ADDENDUM

NO. 3

PROJECT NAME: Lehman High School 2025 Additions and Renovations

ADDENDUM DATE: 14 May, 2025

PACKAGE	VOLUME
Job No. 01954-08-01	Sheet No. ISSUE FOR BID
Drawn By: KAM	Date: 04/22/2025
M2.01B1

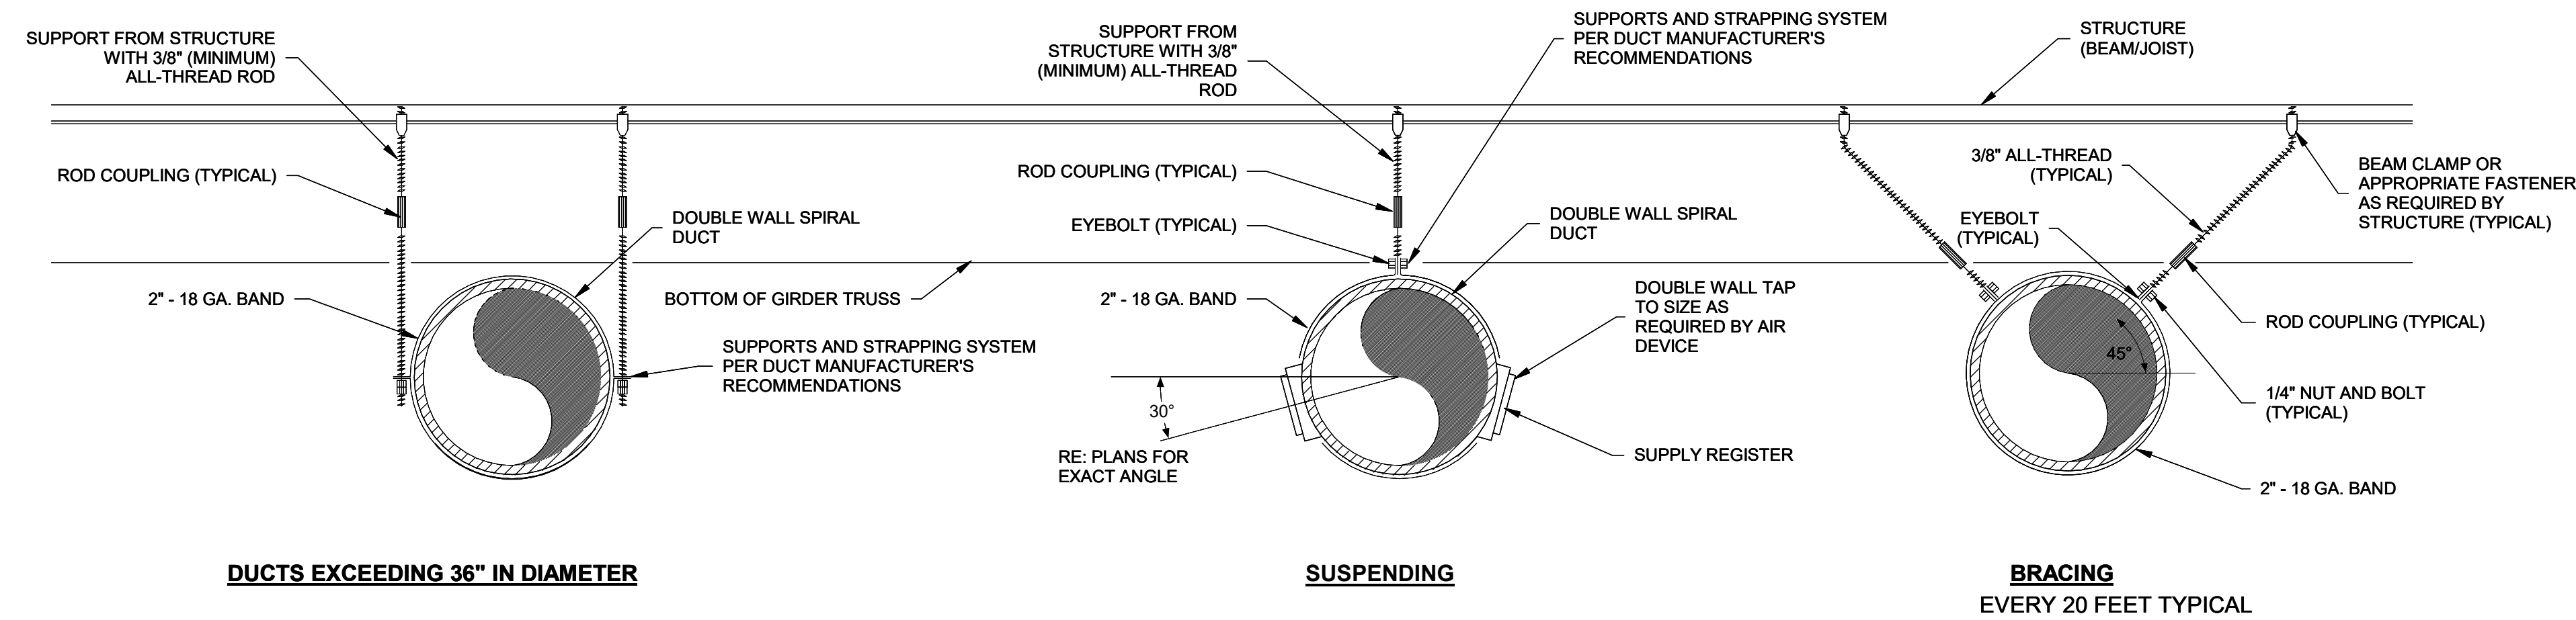
- 2) Revised exhaust in Gang Restroom to have one exhaust register per stall.
- 3) Added keynote M41 about duct to crawl space.

01 FIRST FLOOR PLAN - AREA E - MECHANICAL
SCALE: 1/8" = 1'-0"

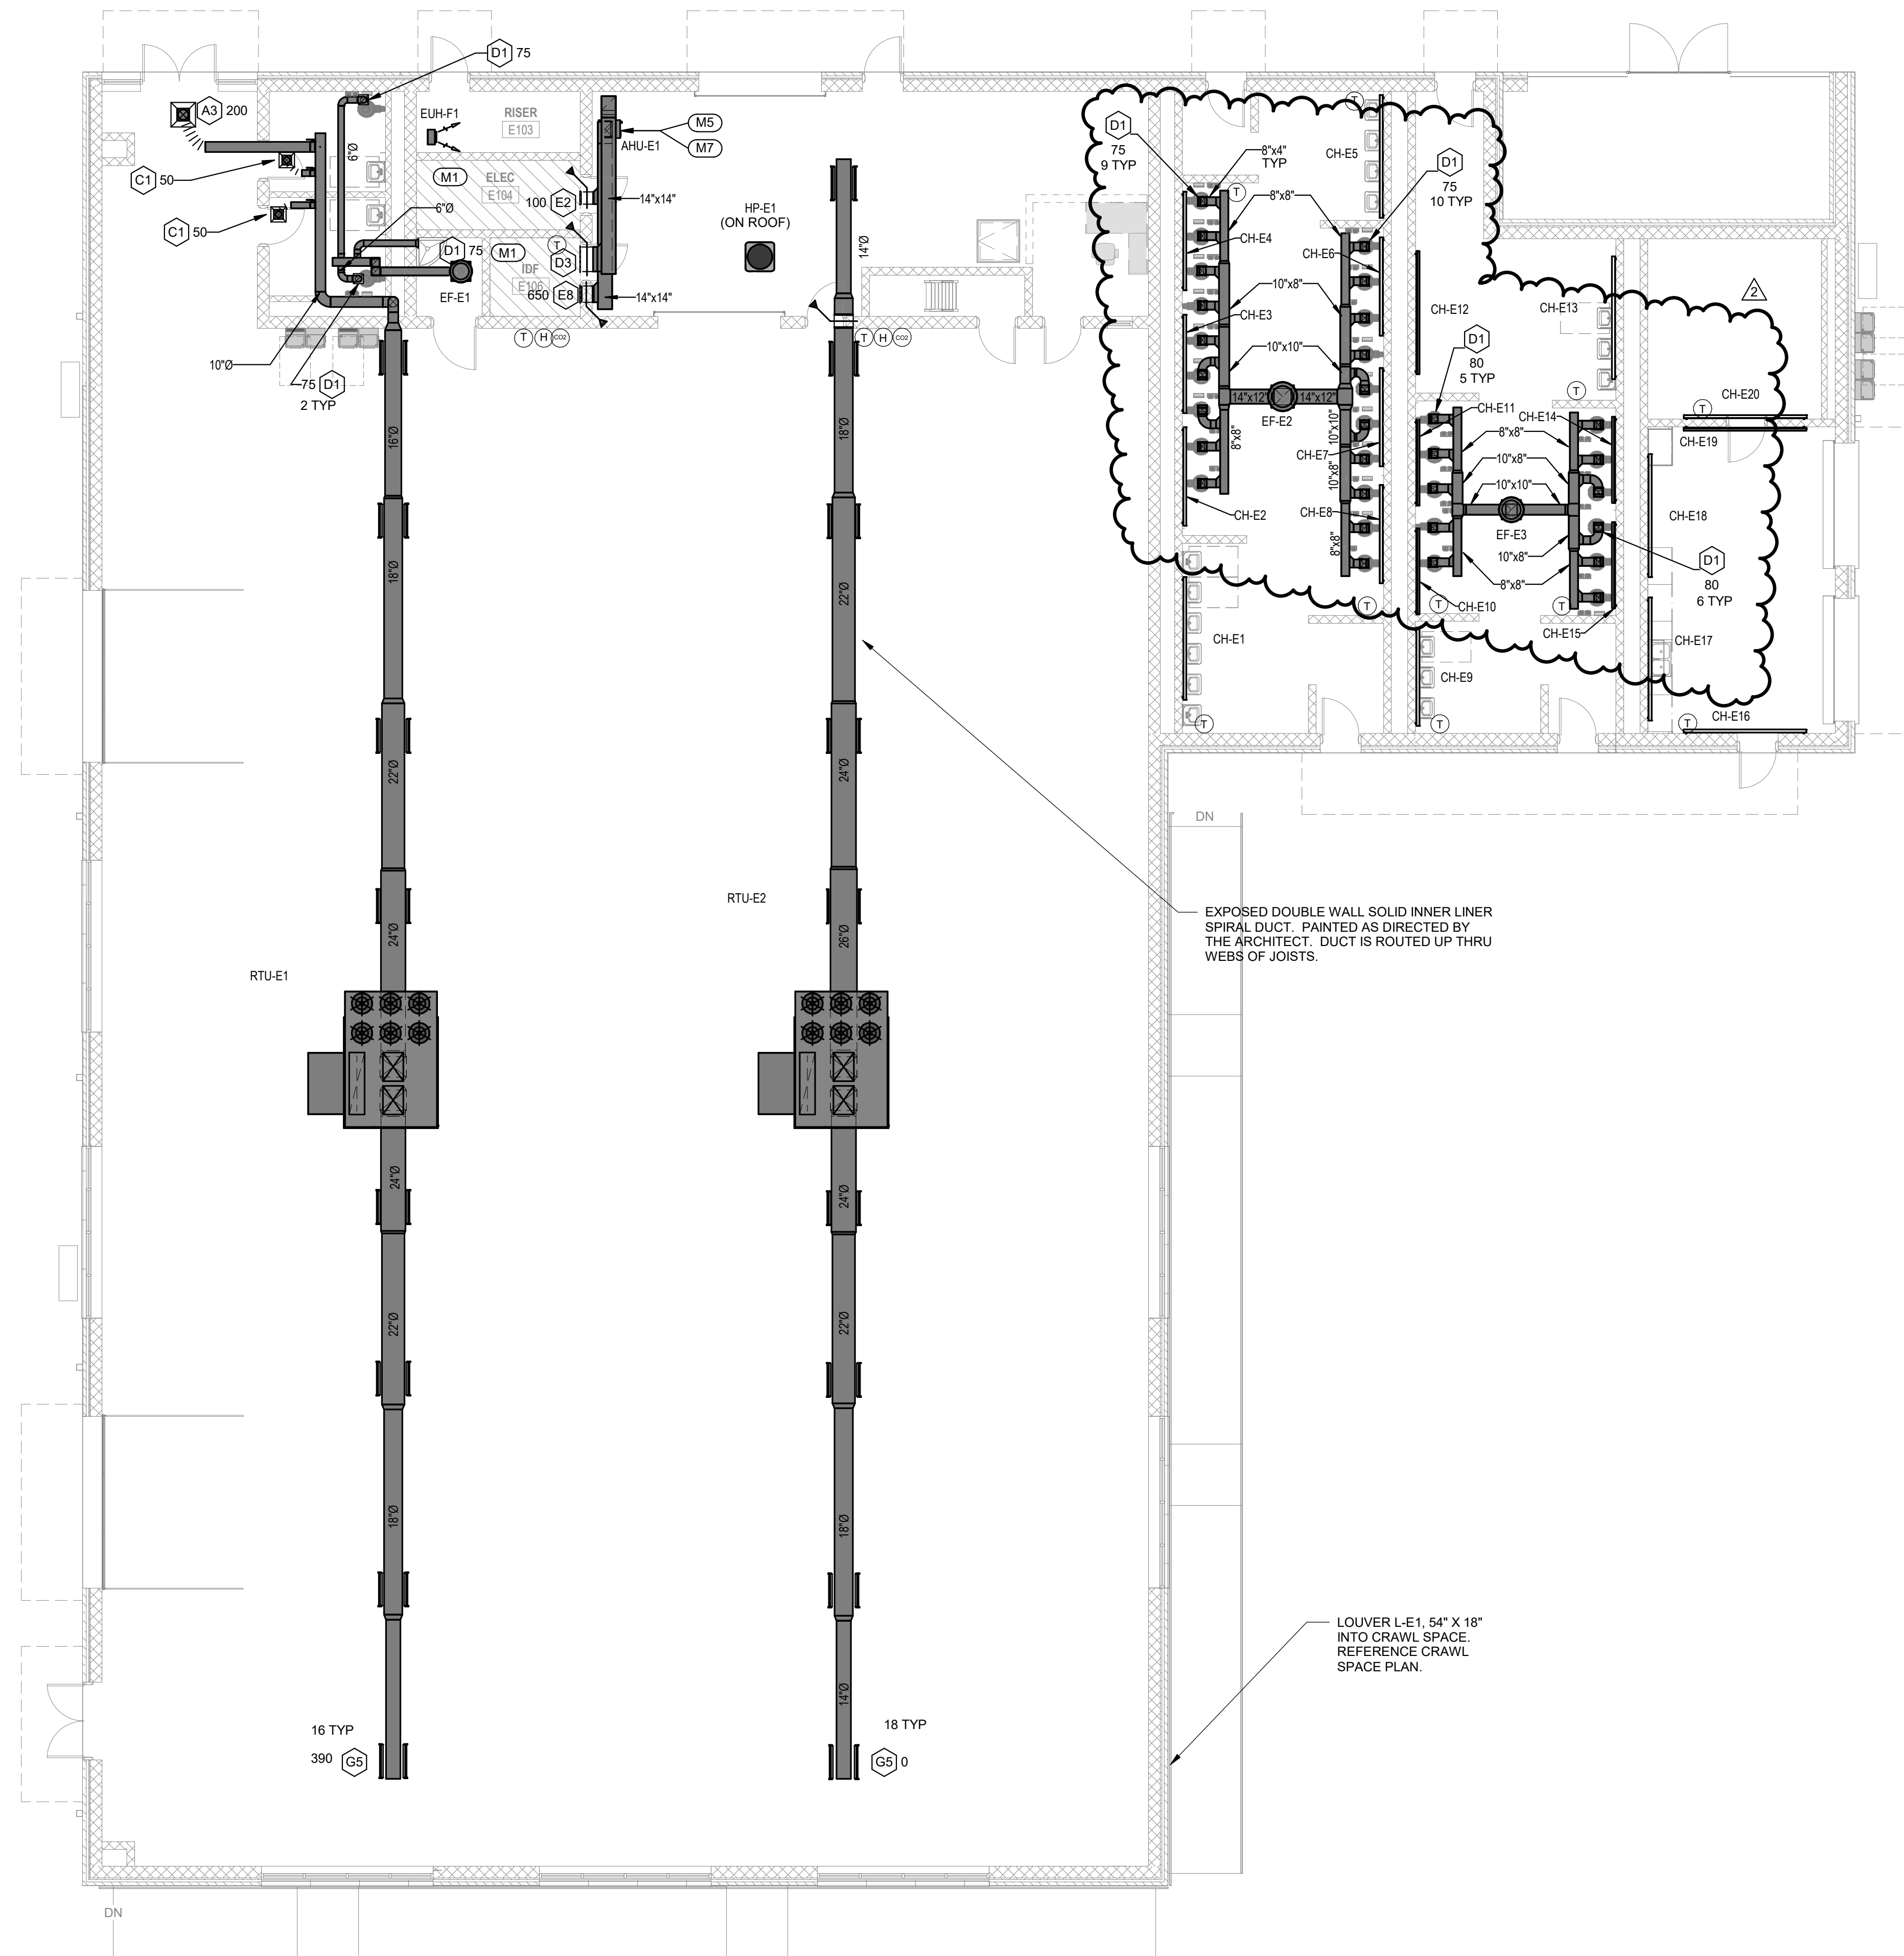
- 4) Added spiral duct detail to sheet. Supply grilles to be set at 30° below horizontal.
- 5) Revised exhaust in Gang Restroom to have one exhaust register per stall.
